UDPRP Review Summary **DRAFT 05.21.21**

Urban Design Peer Review Panel

Below is a summary of the Urban Design Peer Review Panel's advice for the Pearl Lofts project as derived from the May 21st Peer Review session.

PEARL LOFTS
DALLAS, Texas

JAN PRUIT WAY ELEVATION
1" = 20' 0"

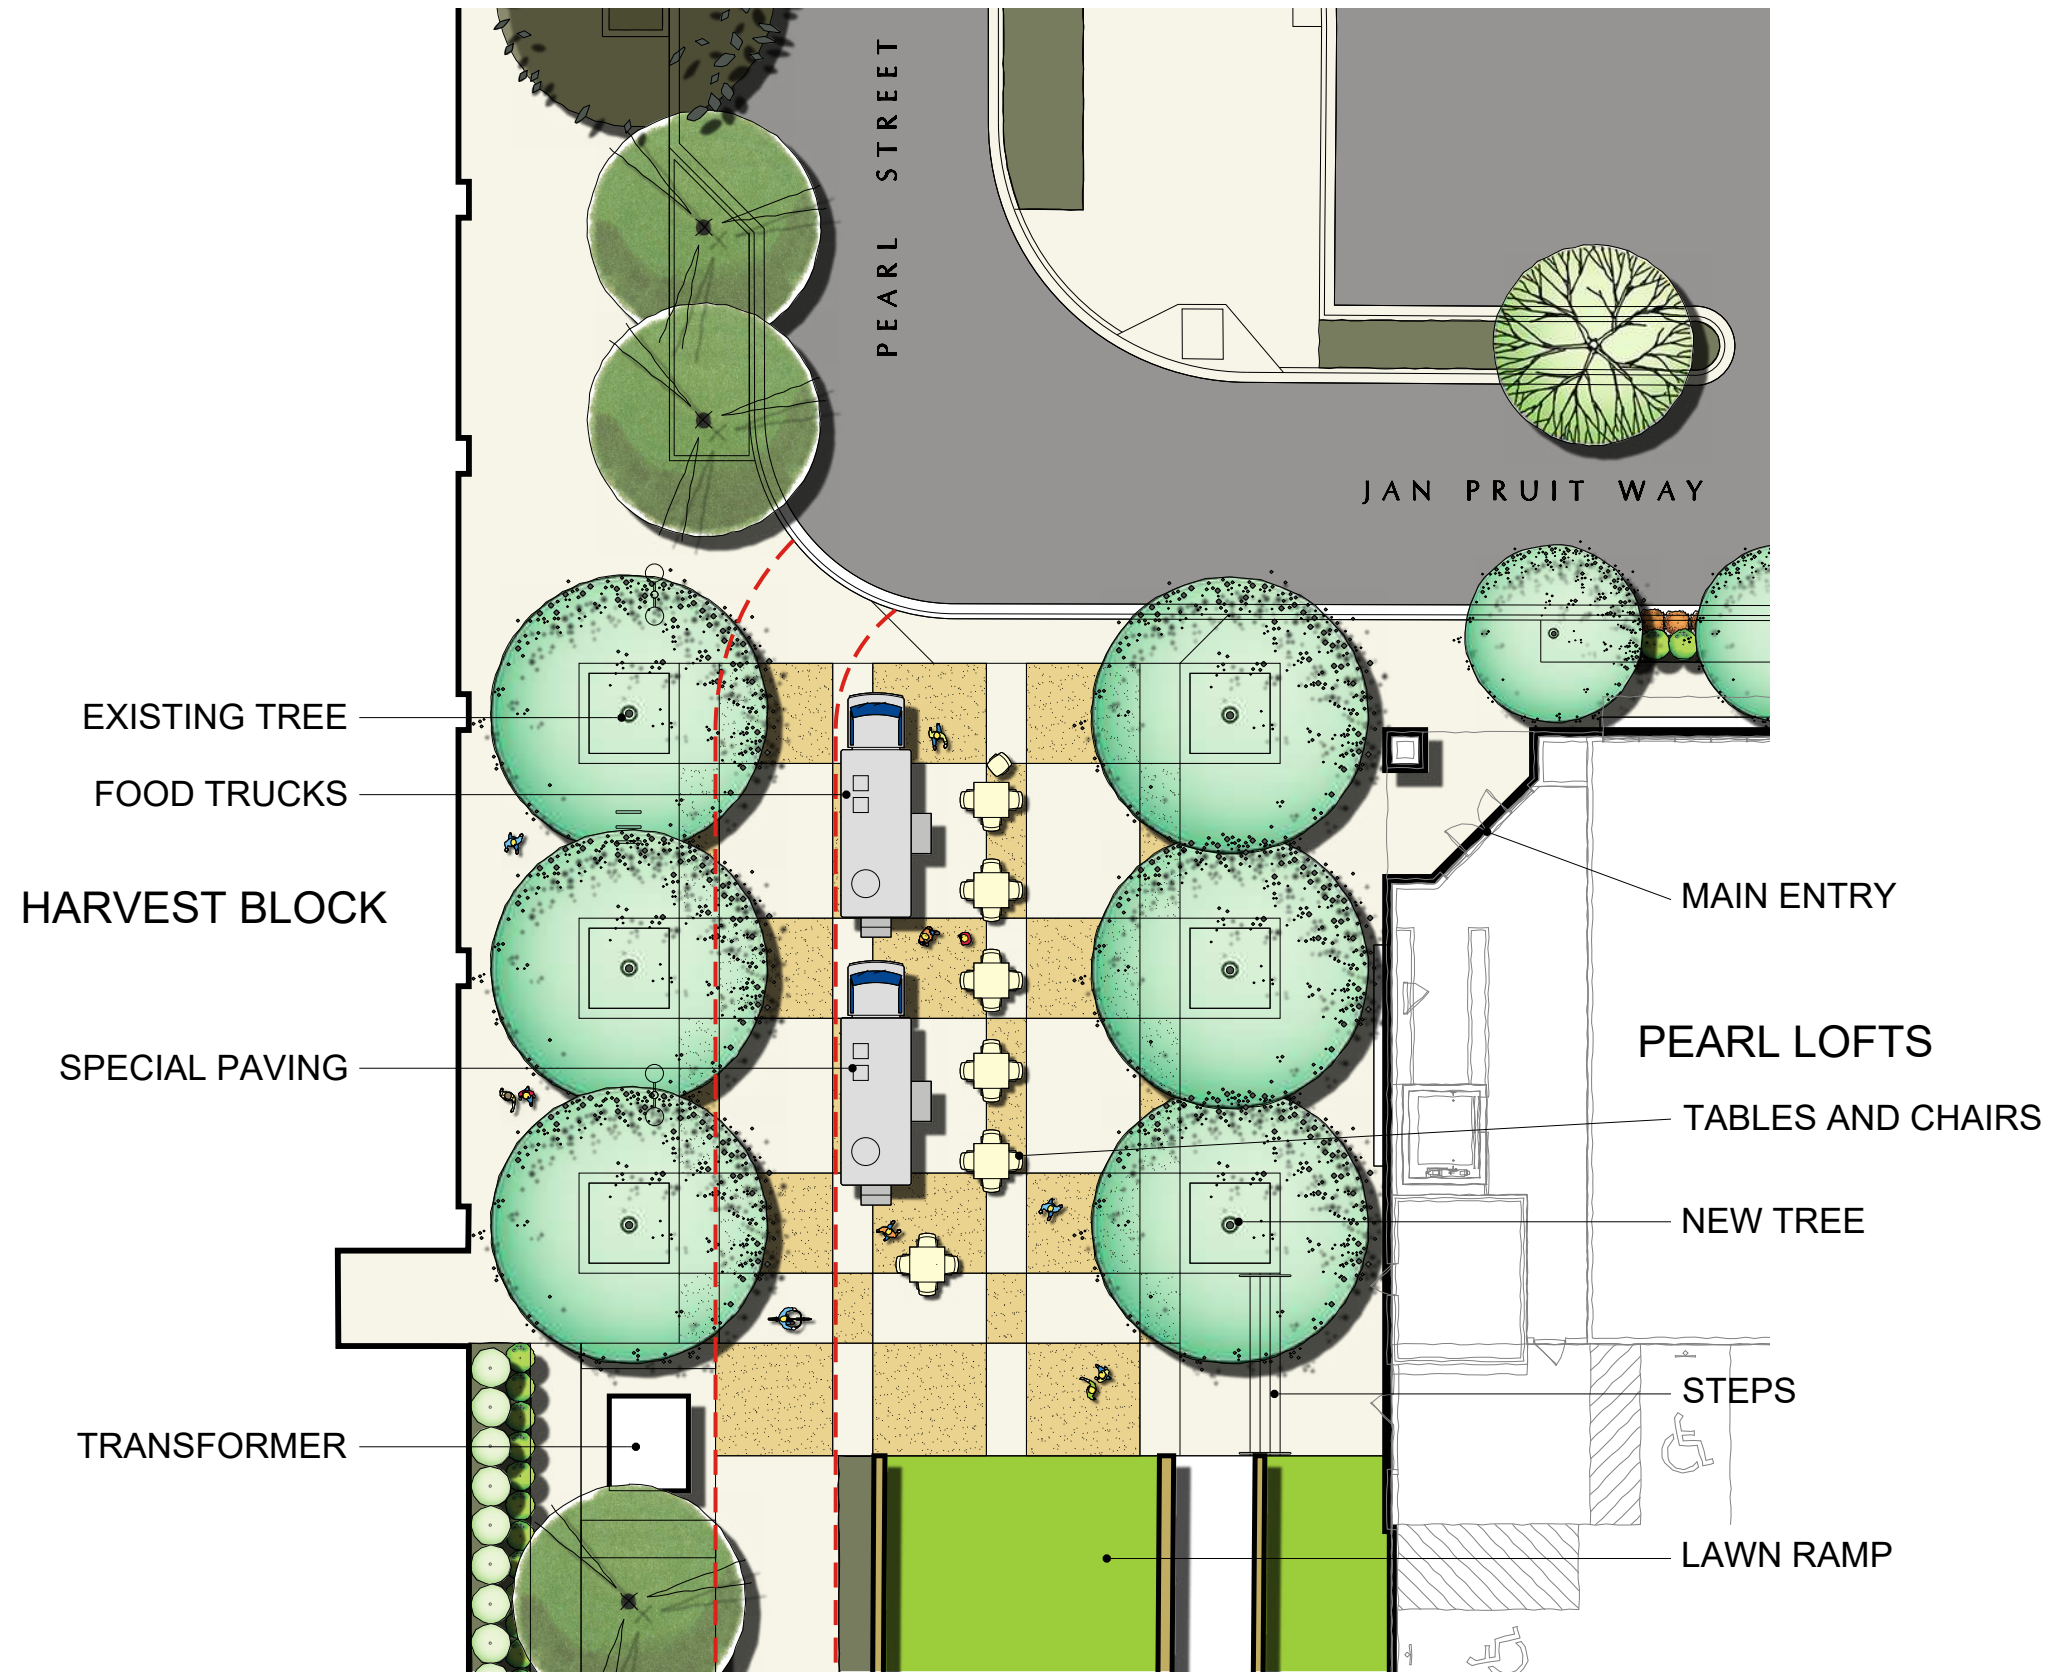
- [4] The Panel suggests the design team further explore the design of the ground-level along Pearl Street and Jan Pruitt Way to provide more transparency and activity along those facades to reinforce the pedestrian nature of this district.

- [6] The Panel recommends that further design refinement be given to the streetscape along Jan Pruitt Way to create a more inviting pedestrian space, including replacing the landscape buffer with tree wells and giving more focused design to the driveway entries into the garage.

- [7] The Panel suggests further design refinement be given to the design of the parking garage façade on all sides to further screen the parking uses and improve the proportionality between openings on the First and Second floors.
